Access Compliance Report

Public Rights-of-Way

(Curb Ramps)

Intersection ID: 47016	Main Street: TRIBUNE_DR	Cross Street: GLAZER_VALLEY_CT	Location: S
ADA ID: 2A6B549CB751	Ramp Type: Perp	Initial Pass/Fail: Fail	Overall Compliance: No
		Severity Score: 37.5

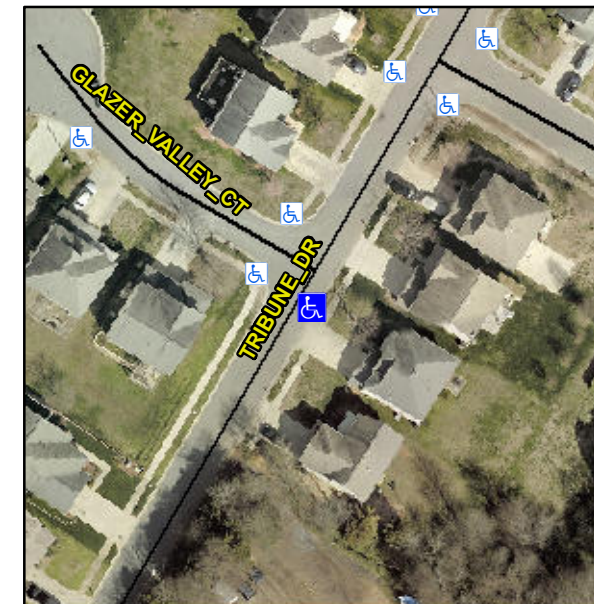
Not Found, R304.2.2, R304.5.3

Compliance	Description	Data	Compliance	Description	Data
N/A	Ramp Length (in)	48.0	No	Ramp Slope (%)	9.7
Yes	Ramp Width (in)	48.0	No	Ramp XSlope (%)	7.3
N/A	Flare Type LT	N/A	N/A	Flare Type RT	N/A
N/A	Flare Slope LT (%)	N/A	N/A	Flare Slope RT (%)	N/A
N/A	Flare Traversable LT?	N/A	N/A	Flare Traversable RT?	N/A
N/A	Landing Length (in)	N/A	N/A	DWS Provided?	N/A
N/A	Landing Width (in)	N/A	N/A	DWS Contrast?	N/A
N/A	Landing Slope (%)	N/A	N/A	DWS Length (in)	N/A
N/A	Landing X Slope (%)	N/A	N/A	DWS Full Width?	N/A
N/A	Landing Curb? (Y/N)	N/A	N/A	DWS Offset (in)	N/A
N/A	Shared Landing?	N/A			
N/A	Gutter Ponding?	N/A	N/A	Gutter Slope (%)	N/A
N/A	Gutter Lip Ht (in)	N/A	N/A	Gutter X Slope (%)	N/A
N/A	Painted X Walk1?	No	N/A	Painted X Walk2?	N/A
	X Walk 1 Direction	To NW		X Walk 2 Direction	N/A
N/A	X Walk 1 Width (in)	N/A	N/A	X Walk 2 Width (in)	N/A
	X Walk 1 Slope (%)	1.4		X Walk 2 Slope (%)	N/A
	X Walk 1 X Slope (%)	6.5		X Walk 2 X Slope (%)	N/A

Remove & Replace Entire Ramp.
